DRAINAGE/GRADING PLAN PARCEL "B"

Sheet Title
GRADING & DRAINAGE PLAN
Checked By
Drawn By BLM

Project Name
PARCEL B & C PASEO DEL NORTE
INDUSTRIAL PARK
ALBUQUERQUE, NEW MEXICO

ENGINEER CERTIFICATION FOR PARCEL "B" PASEO DEL NORTE INDUS. PARK

GRADING/DRAINAGE PLAN SCALE 1" = 20'

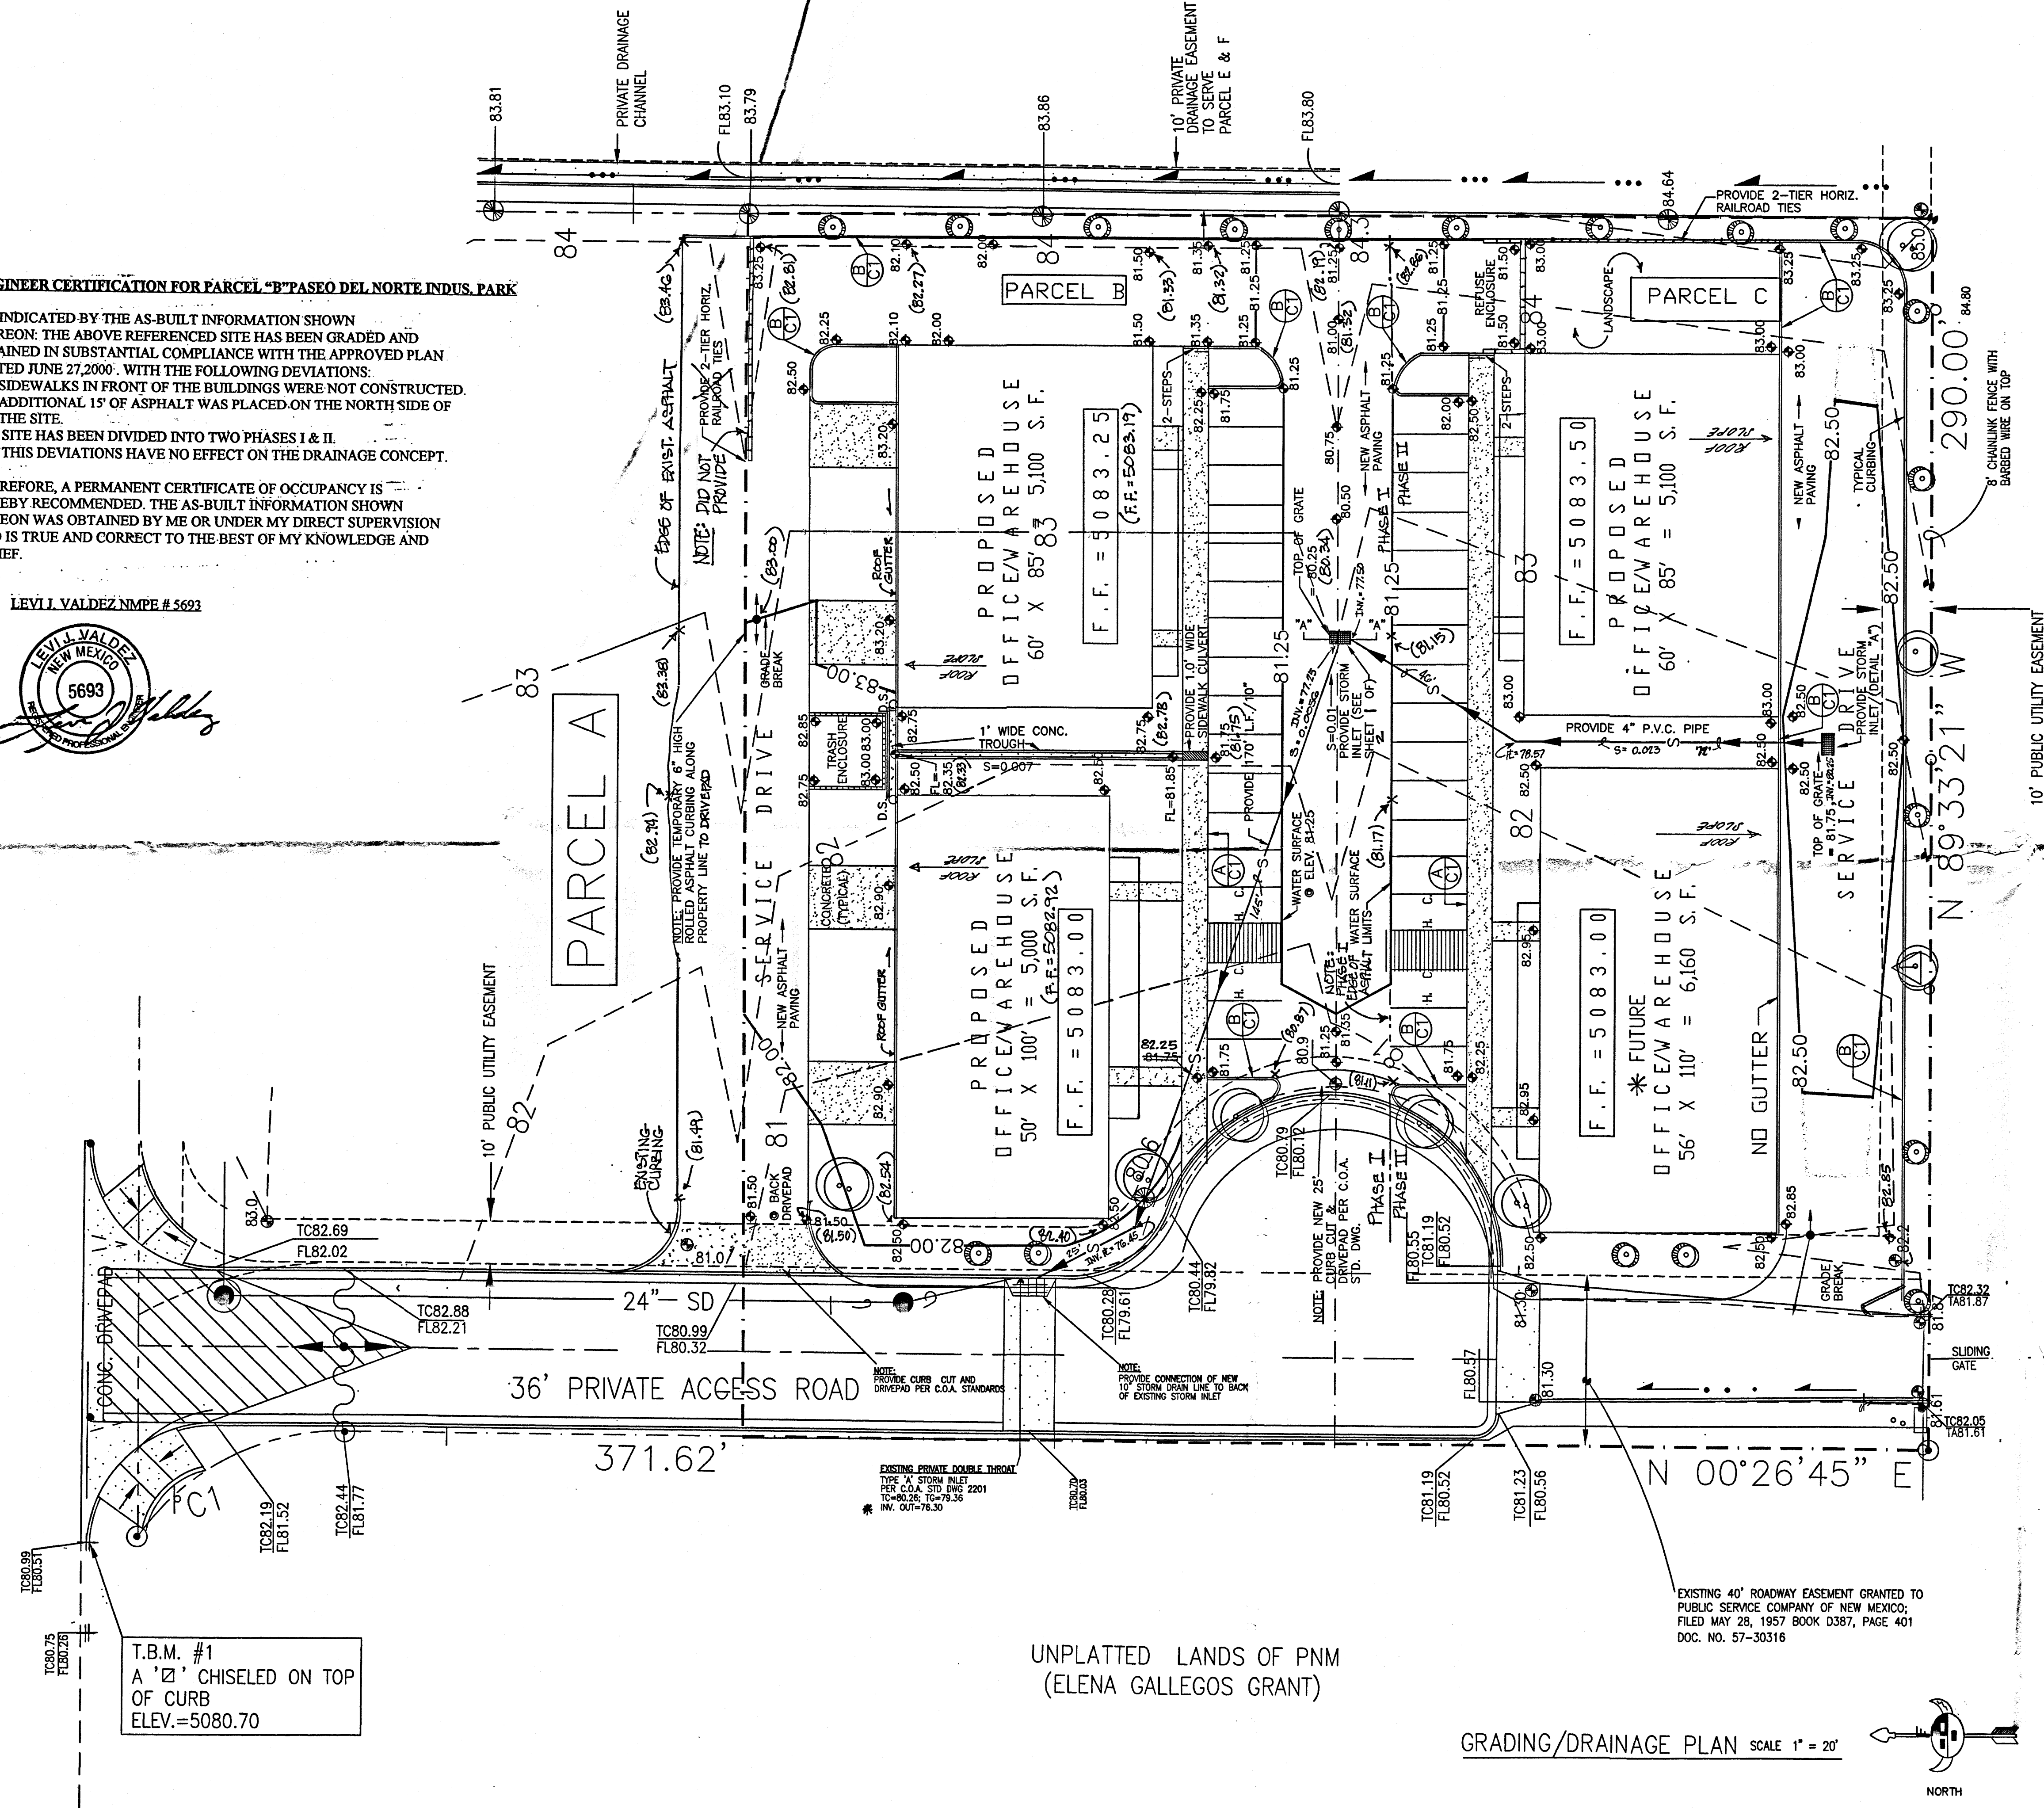
AS INDICATED BY THE AS-BUILT INFORMATION SHOWN HEREON, THE ABOVE REFERENCED SITE HAS BEEN GRADED AND DRAINED IN SUBSTANTIAL COMPLIANCE WITH THE APPROVED PLAN DATED JUNE 27, 2000. WITH THE FOLLOWING DEVIATIONS:

1. SIDEWALKS IN FRONT OF THE BUILDINGS WERE NOT CONSTRUCTED.
2. ADDITIONAL 15' OF ASPHALT WAS PLACED ON THE NORTH SIDE OF THE SITE.
3. SITE HAS BEEN DIVIDED INTO TWO PHASES I & II.

THIS DEVIATIONS HAVE NO EFFECT ON THE DRAINAGE CONCEPT.
